Subject: Site Investigation Work Plan for 4759 North 32nd Street Milwaukee, WI
FID: 341055770 BRRS: 02-41-306192, 02-41-553373, & 03-41-556393

The DNR has reviewed the Site Investigation Work Plan (SWIP) for the Bishop's Creek Community Development Corporation dated September 13, 2017. This letter comments on the SWIP and requests additional information pertaining to the proposal to further evaluate the soil and groundwater contamination on this site. Additional information on the proposal may be required prior to approval. Attached to this letter is a Site Plan Map Figure 2 from Giles Engineering for reference to the items discussed below that includes Lot #3, former Building #3 footing spill excavation area (Drake 2008), and inferred limit of fuel oil release area (Building #1).

FIGURE 2
 SITE PLAN
 BISHOP'S CREEK COMMUNITY DEVELOPMENT CORPORATION
 4729 N. 32ND STREET
 MILWAUKEE, WISCONSIN

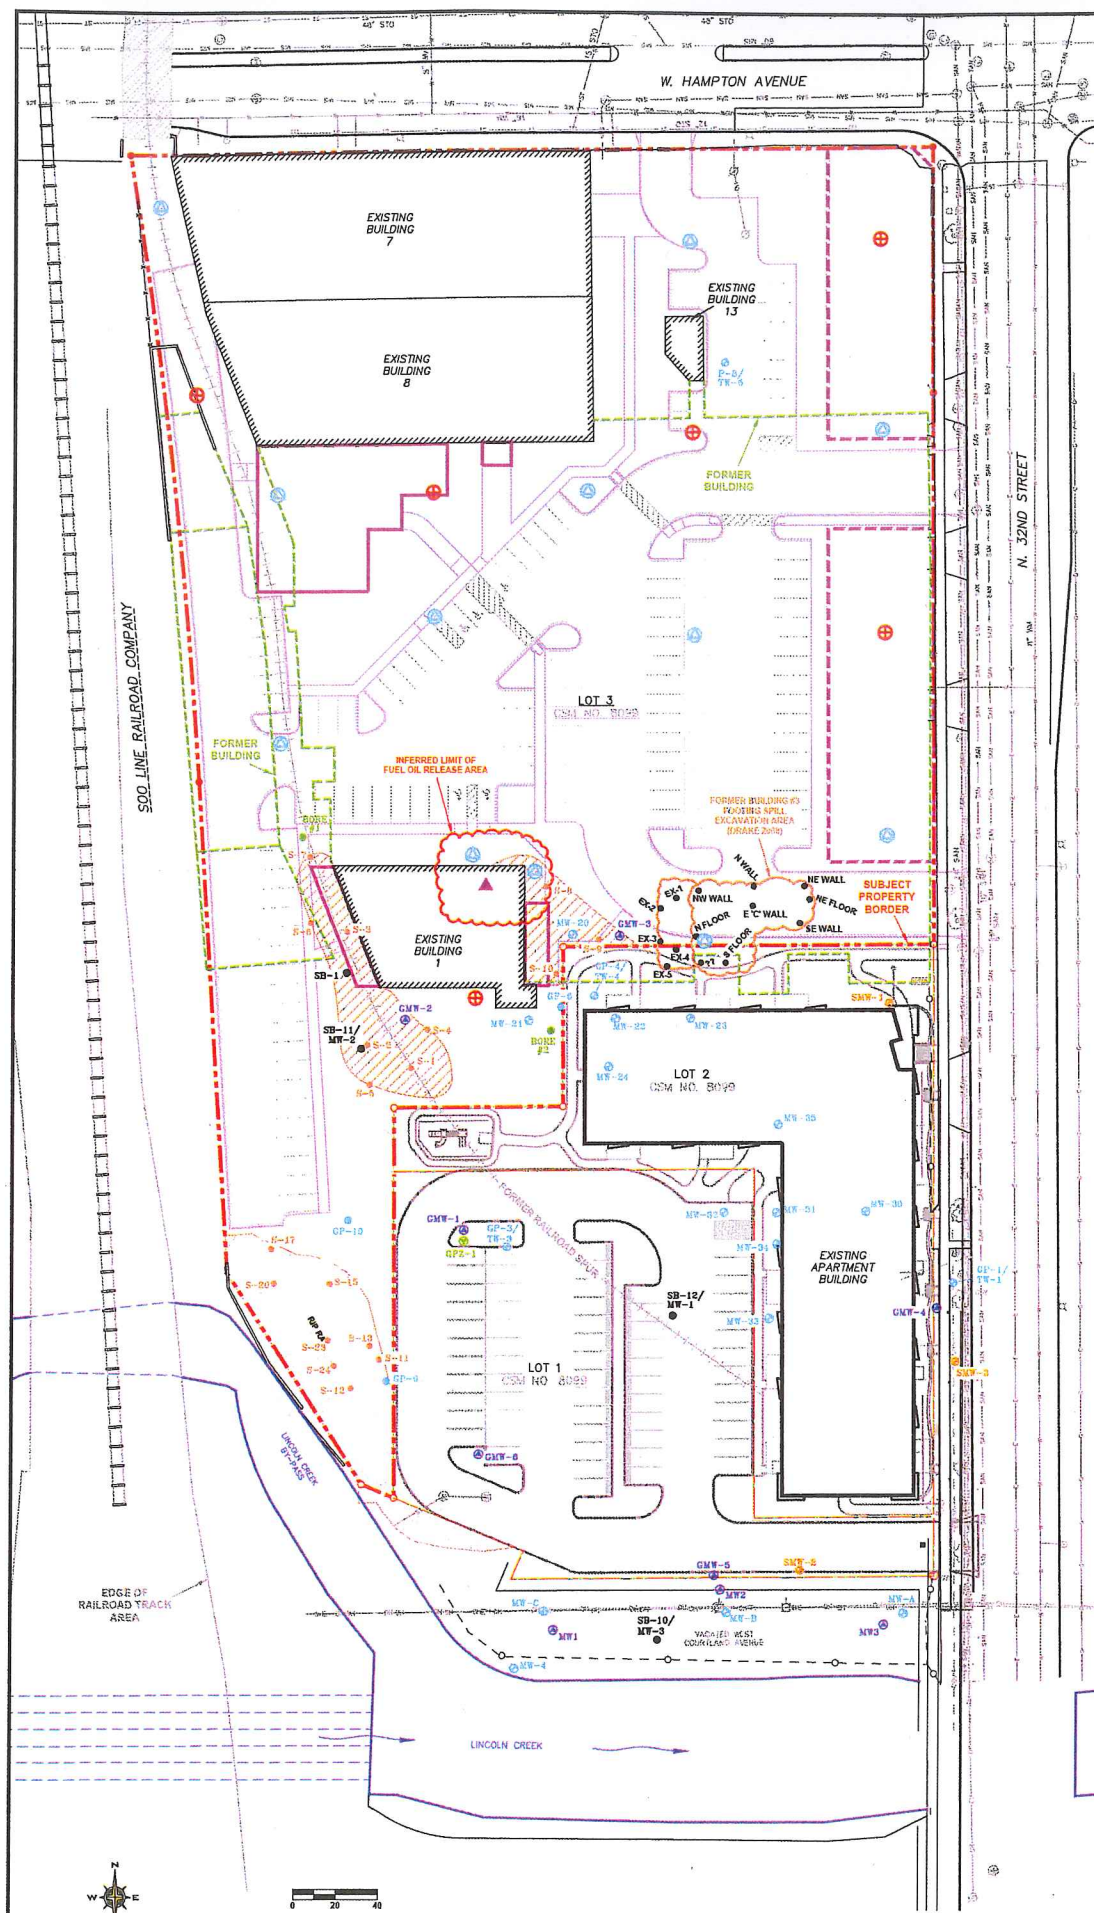
- Groundwater monitoring wells are proposed for two of the three soil boring locations using 1-inch diameter, prepacked well screens. In the Standard Operating Procedures (Page 1, in the submittal), 2-inch diameter screens are discussed. If 1-inch prepacked screens are going to be used, then request a variance per ch. NR 141, Wisconsin Administrative Code (WAC) and change the operating procedures. The operating procedures should indicate how the wells will be constructed using the 1-inch diameter prepacked screens for the proposed wells.

- Three soil boring locations are proposed for this location. Two soil samples per soil boring (six soil samples total) are proposed to be analyzed. The depths where these soil samples are to be taken is unknown but is based on PID/FID screenings. PID/FID screenings within the first zero to two, and two to four feet from the surface are important to evaluate if soil at these depths should be sampled and analyzed for potential direct contact and soil to groundwater pathway issues. The proposal should discuss how the first four feet will be evaluated for potential soil sampling and at what depth the second soil sample will be taken.

- The proposal indicates chemical analysis for petroleum volatile organic compounds (PVOCs), naphthalene, and polycyclic aromatic hydrocarbons (PAHs) in soil for the three soil borings. The DNR recommends RCRA metal soil analysis in addition to the proposed PVOCs, naphthalene, and PAHs because of historical soil and groundwater contamination from lead, arsenic, cadmium, and chromium at the former tannery site. The proposal should be revised to include RCRA metals at the three-soil boring/monitoring well locations.

- The proposed two groundwater sampling events didn't include RCRA metals and volatile organic compounds (VOCs) along with the PVOCs and naphthalene. VOC sampling is recommended to rule out any contamination from chlorinated volatile organic compound (CVOC) contamination from the tetrachloroethene (PCE) and trichloroethene (TCE) spill at the former Building #3 area. Include RCRA metals because of groundwater contamination from metals at the site.

- The proposal didn't address any vapor intrusion pathway assessment for Building #1. The proposal only discussed the installation of a single subslab vapor sampling port, soil sampling of the three soil borings, and groundwater monitoring installation and sampling. The proposal didn't explain how the data will be evaluated for any potential vapor intrusion based on the results.

- The proposal didn't address how the vapor pathway assessment will be conducted at the former Building #3, where there occurred a PCE/TCE discharge from a formerly unknown underground pipe. The assessment should include the groundwater information from the installed monitoring well and former confirmation soil samples from the excavation area.
- The RCRA metals analysis should include cadmium and chromium for the soil and groundwater sample because of known soil and groundwater contamination on the site.
- The groundwater monitoring well should not be abandoned as presented in the proposal. The results may determine if additional site investigation or additional groundwater monitoring will be required at this monitoring point or in conjunction with the groundwater sampling of Northern Lot #3.

- Existing buildings 7 and 8 are in Lot #3 and are considered part of the site investigation. The proposal didn't address sampling of the buildings for potential releases. For example, previous site building inspections by the DNR and EPA in these two buildings and the former tannery buildings had catch basins and drains in the basement floors. These are avenues for releases into the soil and groundwater beneath the buildings. The proposal should address these buildings.

- As in the Building #1 location discussed above, the soil sampling proposal should explain the how the first four feet will be assessed for potential direct contact and soil to groundwater issues and where the additional soil sample will be taken in the soil borings.

- Cadmium and chromium should be included in the RCRA metals analysis from both soil and groundwater samples.
- The groundwater wells shouldn't be abandoned until a determination is made whether these wells may be used in any subsequent or expanded site investigation that may be required based on the data results.

Have Giles Engineering revise the SWIP and submit for approval. Additional site investigation for the site may be required to complete per ch. NR 716, WAC, site investigation, depending on the results of this site investigation work plan.
